Project	<b>IEEE 802.16 Broadband Wireless Access Working Group</b> < <a href="http://ieee802.org/16">http://ieee802.org/16</a> >	
Title	<b>On Concatenation of Block Turbo Codes for OFDMA</b>	
Date Submitted	<b>2004-08-27</b>	
Source(s)	Yougang Zhang, Jun Xu ZTE Inc. 3/F, Bldg.711, Pengji Industrial Park, Liantang, Shenzhen, 518004, P.R.China	Voice: +86 755 26773000 6574 Fax: +86 755 26773000 6616 mailto: <a href="mailto:zhang.yougang@zte.com.cn">zhang.yougang@zte.com.cn</a> mailto: <a href="mailto:xu.jun@zte.com.cn">xu.jun@zte.com.cn</a>
Re:	Response to the call for contributions to IEEE Standard 802.16-2004, IEEE 802.16maint-04/01, 2004-08-04. Header error fix to IEEE 802.16maint-04/29.	
Abstract	This contribution presents modifications to coding parameters of Block Turbo Codes for OFDMA in IEEE Standards Draft 5. With these modifications the code rate of every redesigned encoding patterns based on BTC will be exactly 1/2 or 3/4 and the information bits will have an exact multiple relations, not approximate as previous encoding patterns specified previously have.

# On Concatenation of Block Turbo Codes for OFDMA

Figure 1 Performance comparison between the proposed coding parameters and those specified in the first row of table 321 in Draft 5

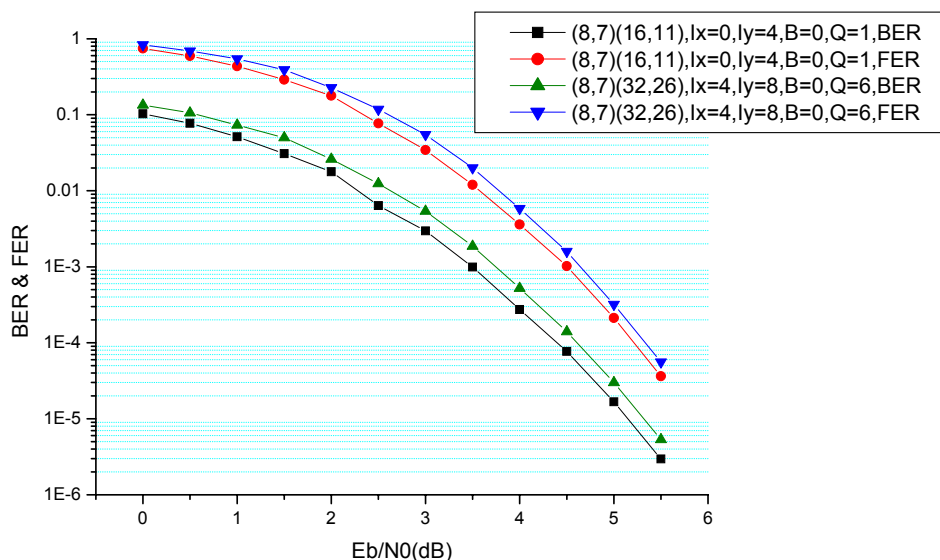
We have replaced the encoding parameters listed in Table 320 and Table 321 with the new encoding parameters. And the new designed encoding patterns have either better performance, or exact 1/2 or 3/4 code rates, which are required by concatenation rule specified in [1]. Such as for the encoding pattern of the first row of Table 320, we adopted (8,7) (16,11) as the component codes and the shorten parameters are  $I_x=0, I_y=3, B=8, Q=0$ , not the corresponding encoding pattern in [1], which adopts (8,7) (32,26) as component codes and the shorten parameters are  $I_x=4, I_y=8, B=0, Q=6$ . Both of these two patterns have an exact code rate 1/2, and the reasons for adopting the former are as follows:

- 1, Encoding of the extended Hamming component code (16,11) will be simpler than that of (32,26).
- 2, Simulation shows that the performance of BTC adopting (8,7)(16,11) as its component codes is superior to that of adopting (8,7)(32,26) as component codes, as illustrated in Fig. 1.
